Replies to Anonymous Referee #1

“Assimilation of DAWN Doppler Wind Lidar Data During the 2017 Convective Processes Experiment (CPEX): Impact on the Precipitation and Flow Structure”

Svetla Hristova-Veleva et al. (AMT-2020-503)

Figure A. “Hand-drawn” dropsonde analysis from Zipser and Rajagopal (2018).

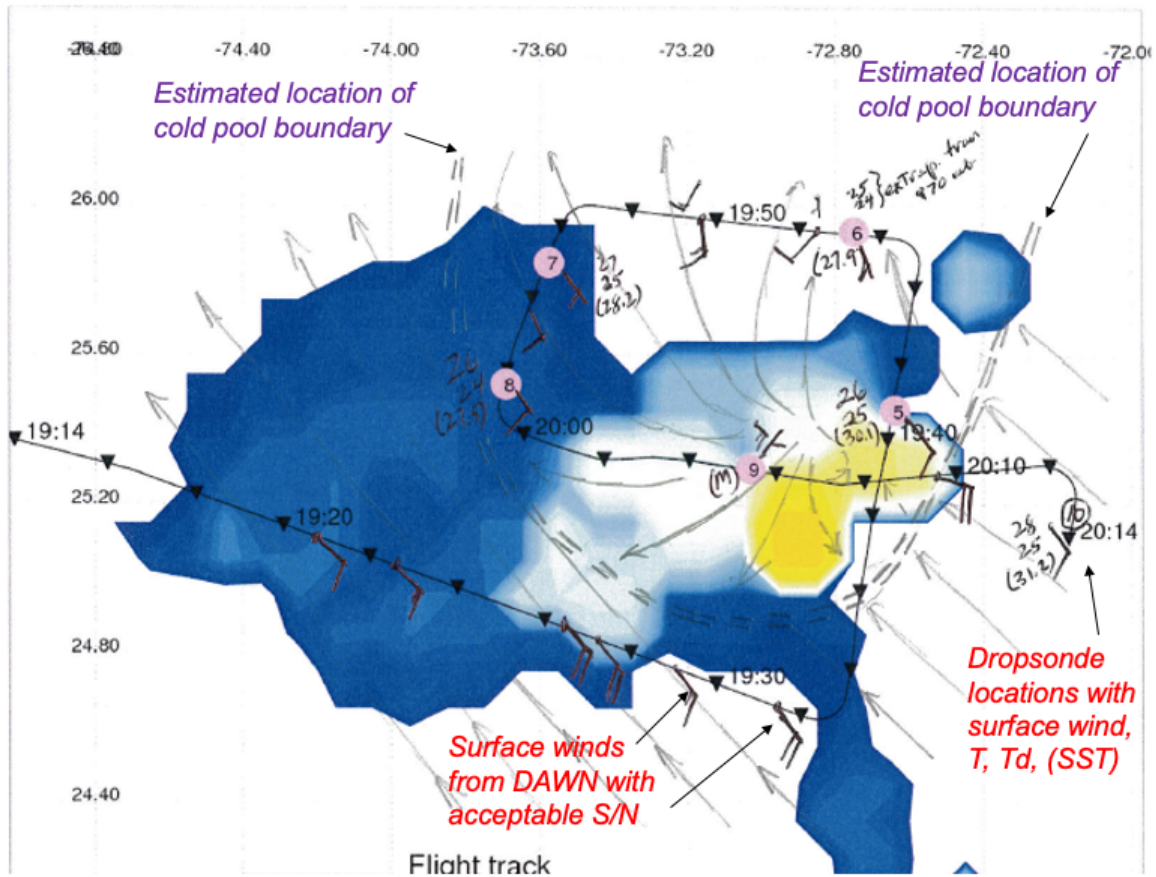
Figure 18, should the temperature anomaly in color shading in Figure 18b be aligned in some sense with the cold pool boundary? I am seeing a disconnect and am confused. I realize that the dropsondes revealed a cold pool there but I'm guessing a more substantial cold pool would have been found near the precip in the lower right quadrant of the domain had you released dropsondes there. Perhaps the red line is not particularly important because it confuses the interpretation of Fig 18b,

The red line is the boundary that was taken from the Zipser and Rajagopal analysis of this same flight date (shown in Figure A below), using their analysis of dropsonde and GPM IMERG data. We feel that this boundary does give overall context to the "after-assimilation" depiction, as the cold pool signature is a manifestation of temperature and moisture conditions. Granted, this is based on limited observational data. Since the analysis is limited to only a few dropsondes on this particular day, it's entirely possible that a more substantial cold pool would have been revealed further south. However, in contrast to the simulations, the observations did not reveal a precipitating system further south.
